**UPDATE CHANGE NOTIFICATION # 16361**

**TITLE: Marking and Ordering Information Update for Gresham die based 2Kb I<sup>2</sup>C Serial EEPROM Devices (CAT24C02)**

SOIC (W)

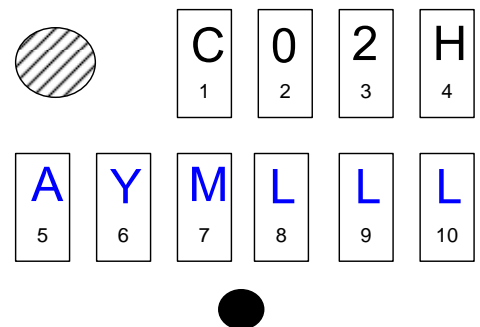
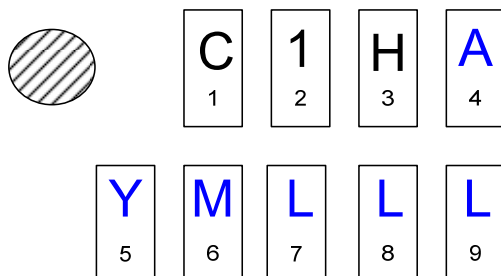
Package marking for 2Kb I<sup>2</sup>C Serial EEPROM devices fabricated with Gresham die (presently offered under OPNs terminated with 'A') will be updated, as compared to the format previously published in FPCN 16361, in order to align the marking for these devices to the improved marking format most recently announced for 4Kb to 64Kb I<sup>2</sup>C devices fabricated with Gresham die (FPCN 16476). This marking update provides an easier identification of device, die revision and package, as requested by our customers.

The new marking shown in the attached Appendix will be used starting with date codes containing August, 2010.
